Re: FortisBC Energy Inc. (FEI)

Application for a Certificate of Public Convenience and Necessity (CPCN) for Approval of the Lower Mainland Intermediate Pressure (IP) System Upgrade (LMIPSU) Projects (the Application)

Response to the British Columbia Utilities Commission (BCUC or the Commission) Information Request (IR) No. 2

14 Figure ES-1-supp.* Aggregate "As Is" economic consequences of outage without LMSU Projects

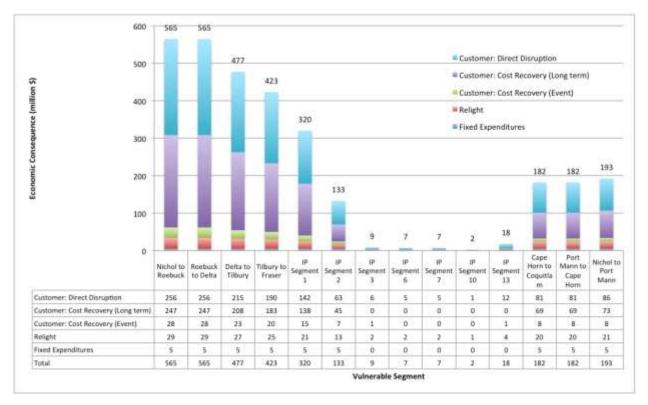
Please recalculate Tables ES-2a, ES-2b, 3.1, 3.2 and Figure ES-1

- 1 To illustrate this, updates to the indicated tables and figures have been prepared to show the
- 2 shift in incidence and are provided below along with additional notes to assist in interpretation.
- 3 These supplementary graphics are numbered as follows to correspond to the originals in
- 4 Appendix 5: Table ES-2a-supp, Table ES-2b-supp, Figure ES-1-supp, Table 3.1-supp, Table
- 5 3.2-supp.
- 6 Table ES-2a-supp.* Reference Case "As Is" economic consequences (millions \$; 2014\$) showing
- 7 distribution of customer impact if net revenue losses to FEI are nil due to availability of cost
- 8 recovery mechanisms.

1 These supplementary (supp) tables vary little from the originals but most of the incidence of impacts is now borne 2 entirely by customers if the company has mechanisms available to recover near- and long-term revenue losses that 3 would otherwise accrue due to loss of customers. Also, some of the longer term impacts due to rate increases from 4 cost recovery mechanisms represent a minimum (floor) value; these are represented in this version by the addition 5 of a greater than (">") sign. These incremental amounts result from potential customer losses due to price-elasticity 6 effects from the first round of impacts. The incremental impacts would be positive but they are in effect neglected 7 here due to the difficulty in providing guantitative estimates: their estimation depends on speculating on the second 8 round consequences of an avoided event which itself is a rare occurrence with which the industry has little 9 experience. There is no reliable basis for estimating a demand function for such an event, although it can be 10 reasonably assumed that the price elasticity of demand is negative such that the higher tariffs lead to further 11 customer losses; hence it is appropriate to indicate that the impacts for some of these (including total 12 consequences) are now potentially higher than the originals.
